ADDENDUM NO. 1

VILLAGE OF VERSAILLES North West Street Extension

March 19, 2018

Re: Village of Versailles
North West Street Extension

WATER MAIN SERVICE CONNECTION

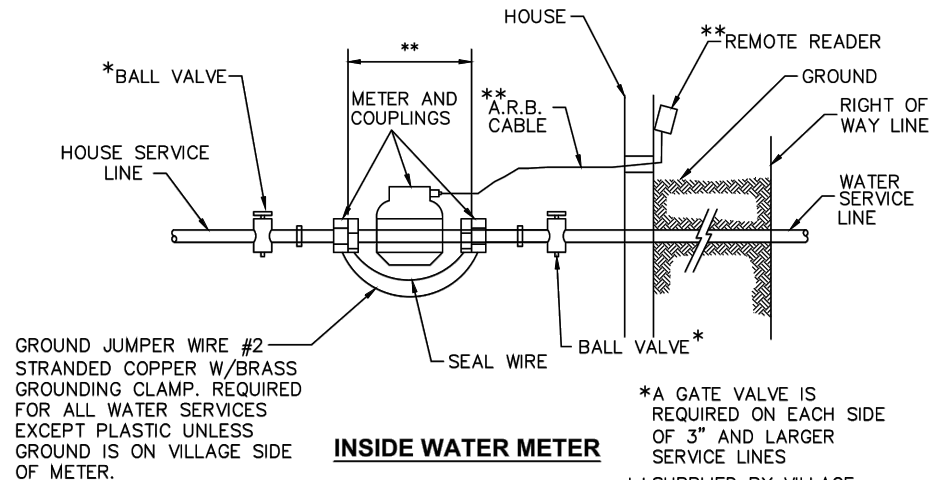
- A) Water Main Service Detail (800-7): The curb valve shall be revised to Mueller B-25209. A revised Detail showing this change is attached.
- B) Fire Hydrant Detail (800-1): On the hydrant tee detail plan, the pipe between the watch valve and fire hydrant shall be 6" C-909, 36" minimum length. A revised Detail showing this change is attached.

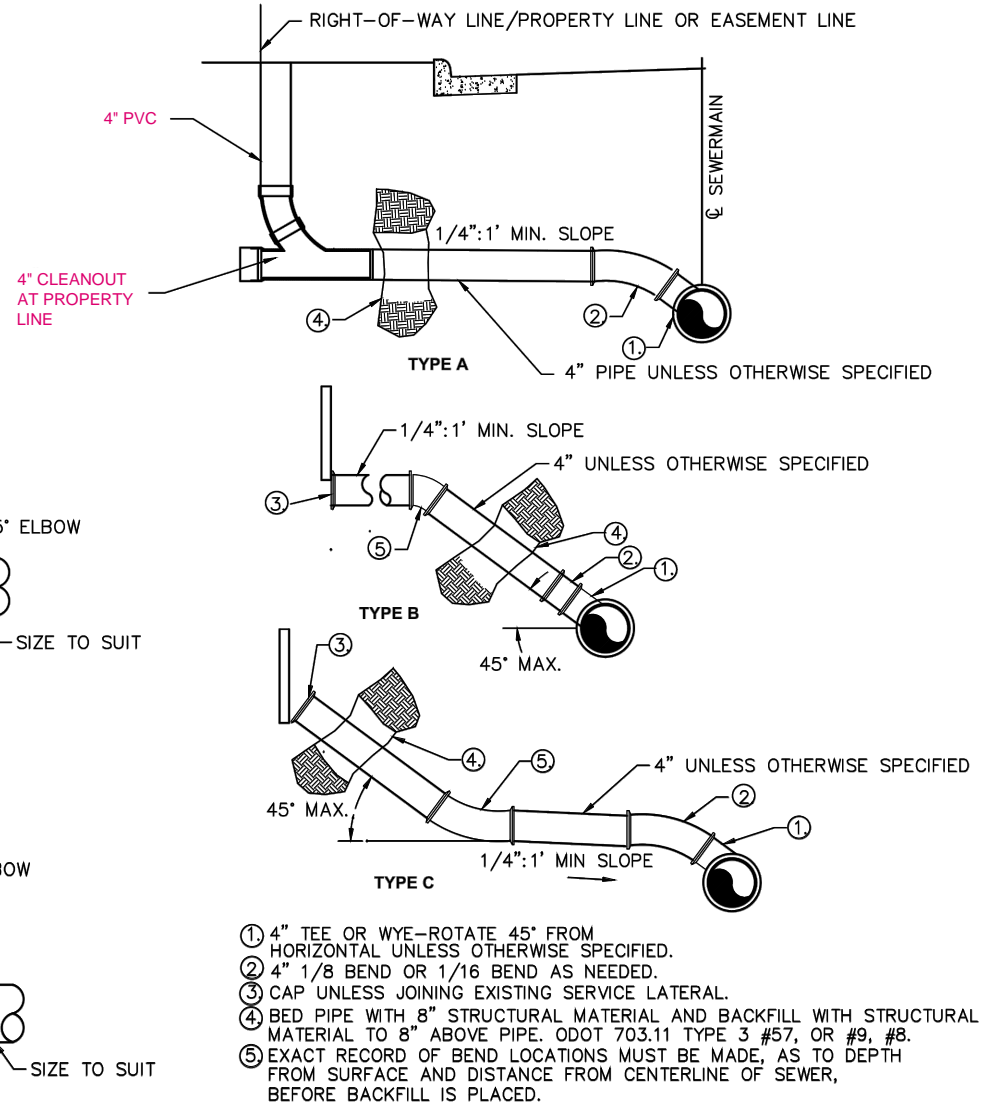
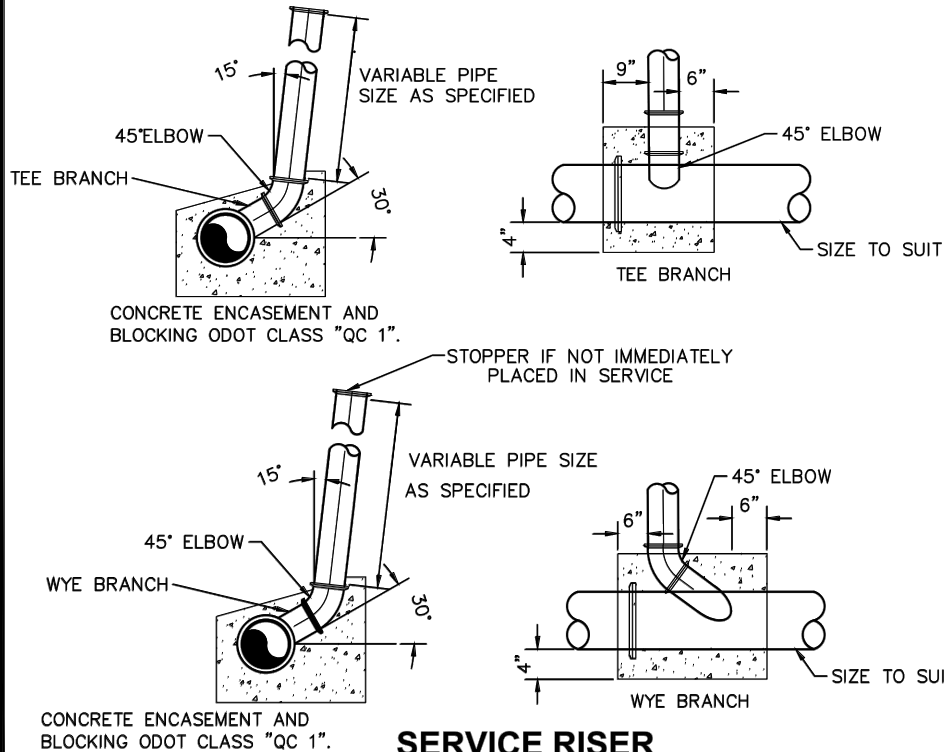
- A) Service Riser and Service Lateral Detail (900-7): The cleanout riser shall be 4" PVC. A revised Detail showing this change is attached.

CLEANOUT DETAIL

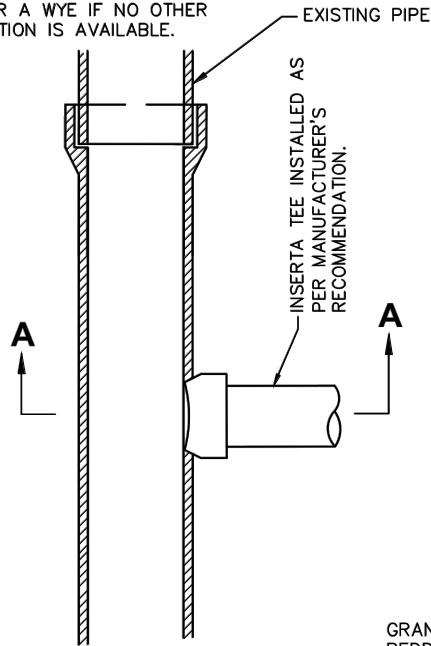
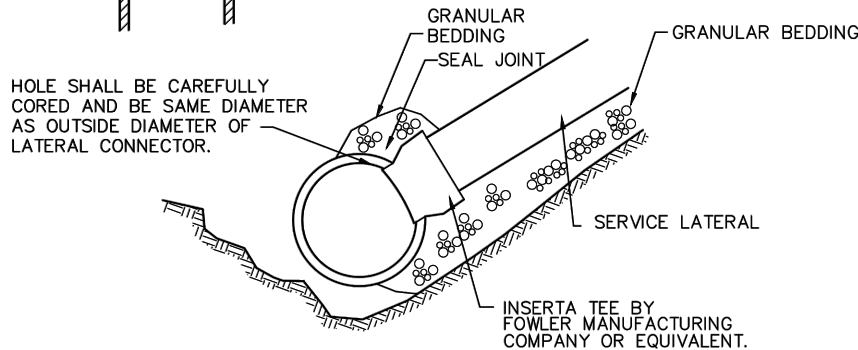
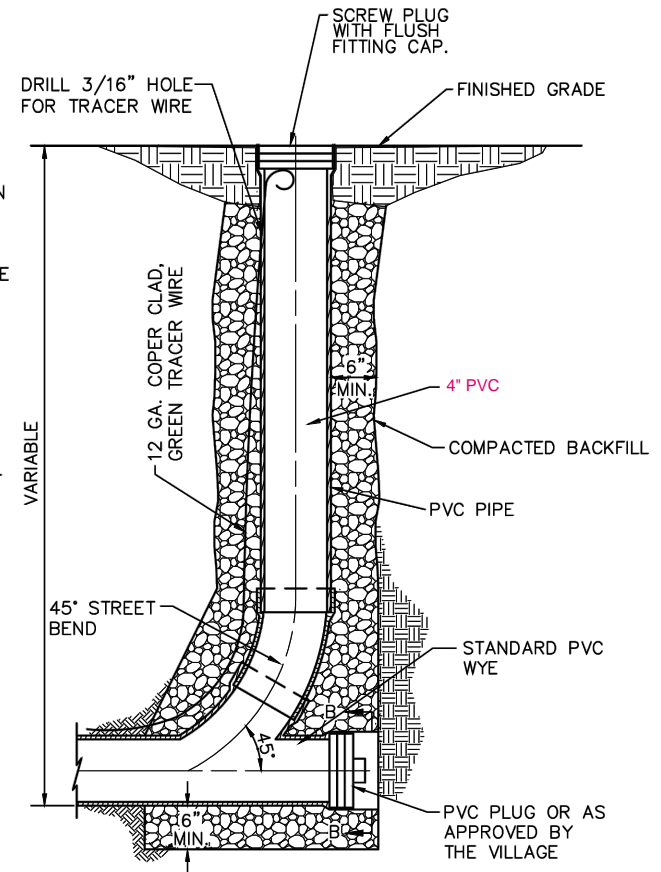
- A) Sanitary Sewer Cleanout and Inserta Tee Detail (900-9): The cleanout riser shall be 4" PVC. A revised Detail showing this change is attached.

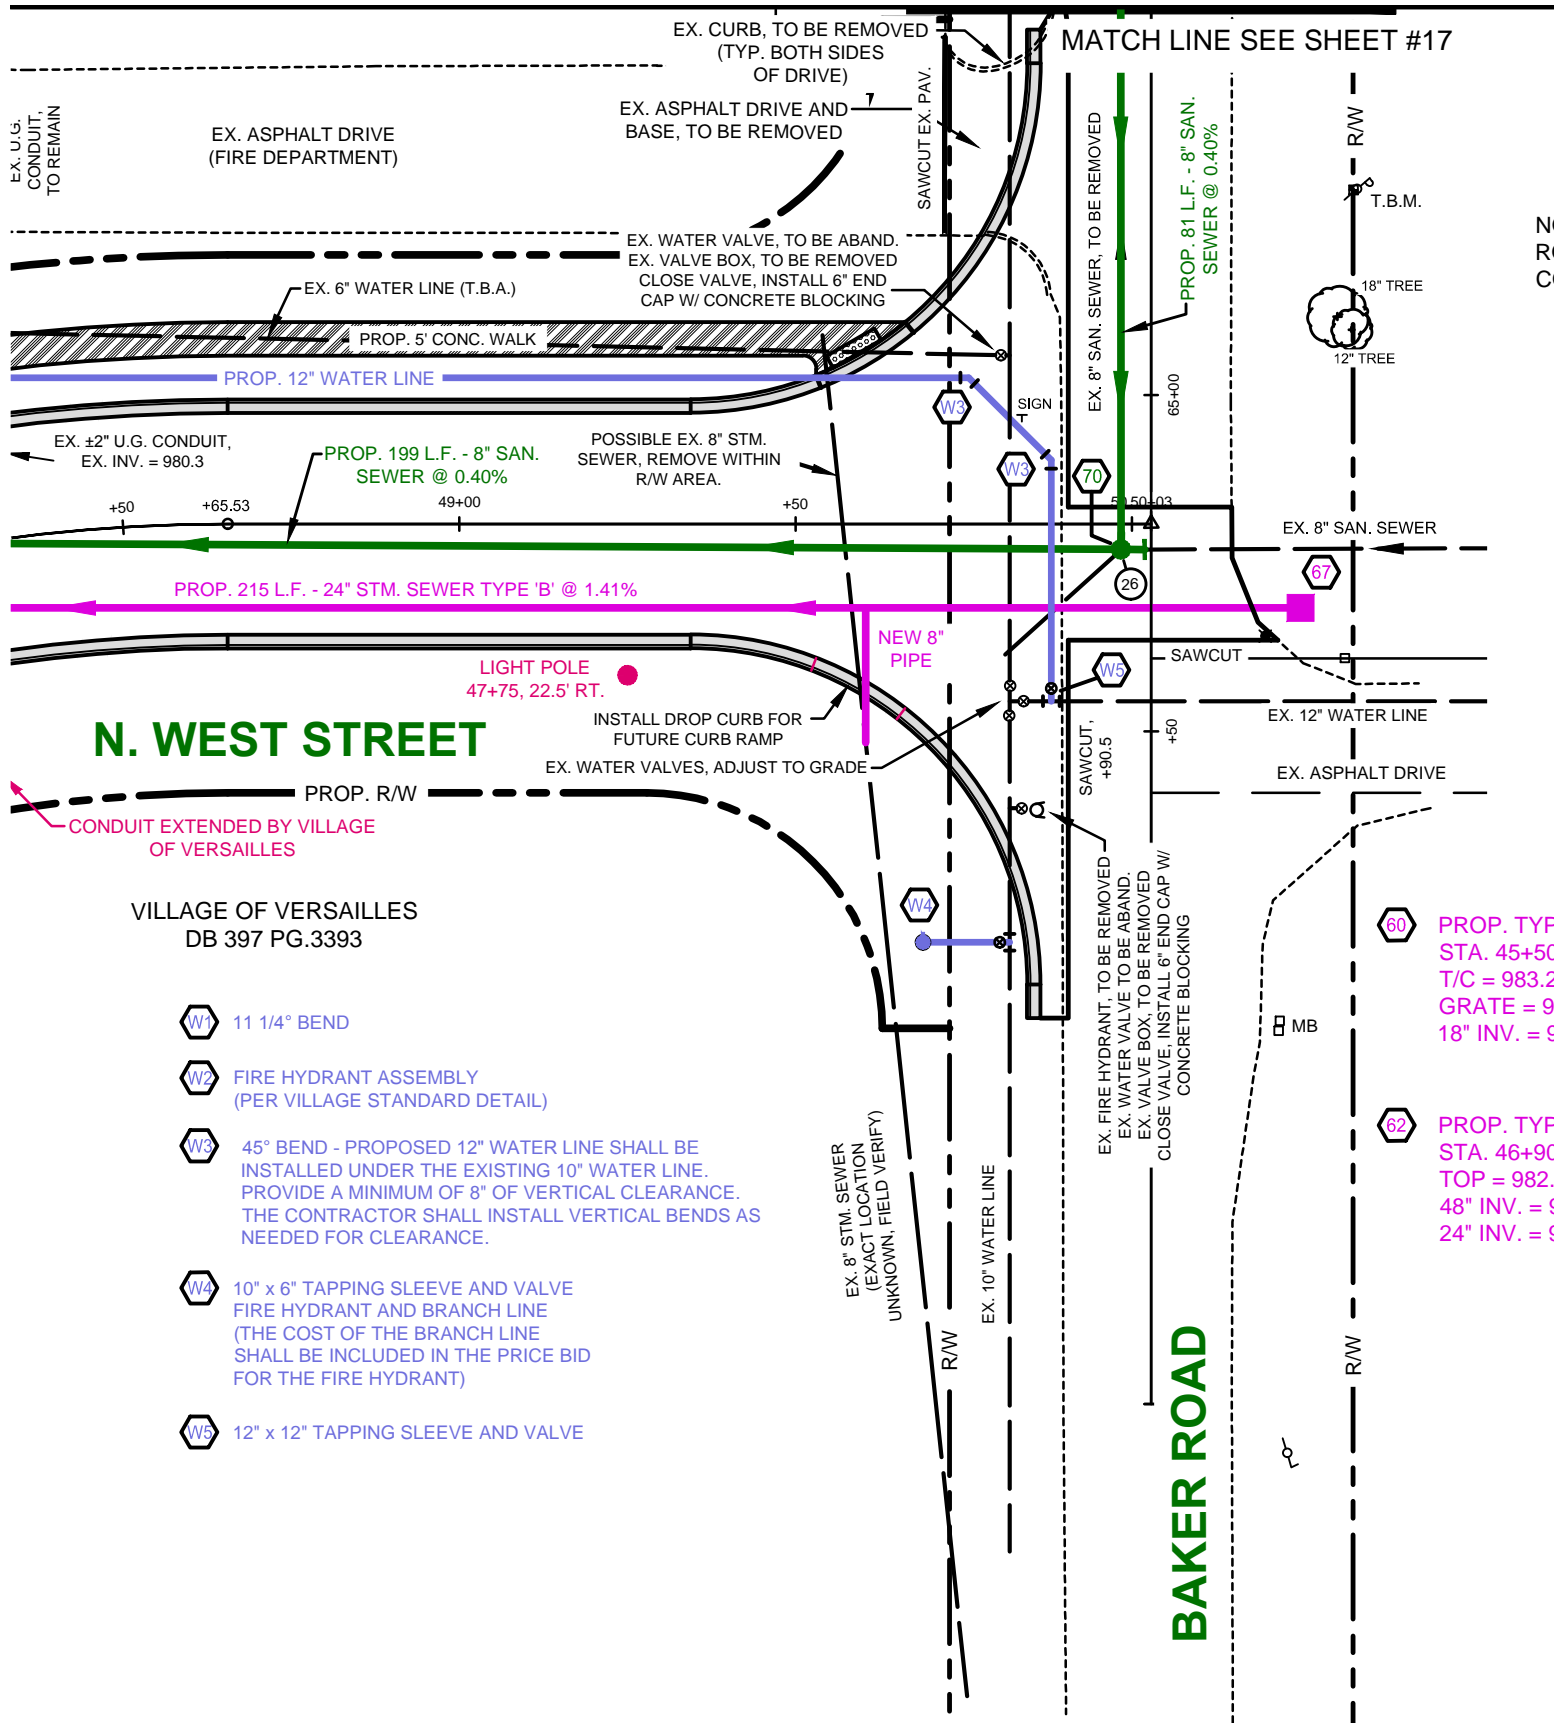
- A) A revision to the water line layout at the intersection of North West Street and Baker Road has been made. The revised layout will result in quantity adjustments of the addition of 45 L.F. of 12" Water Line w/ Granular Backfill, eliminating the 10" x 10" Tapping Sleeve and Valve, and the addition of one 12" x 12" Tapping Sleeve and Valve. A revised detail showing this revision is attached.

W5 12" x 12" TAPPING SLEEVE AND VALVE
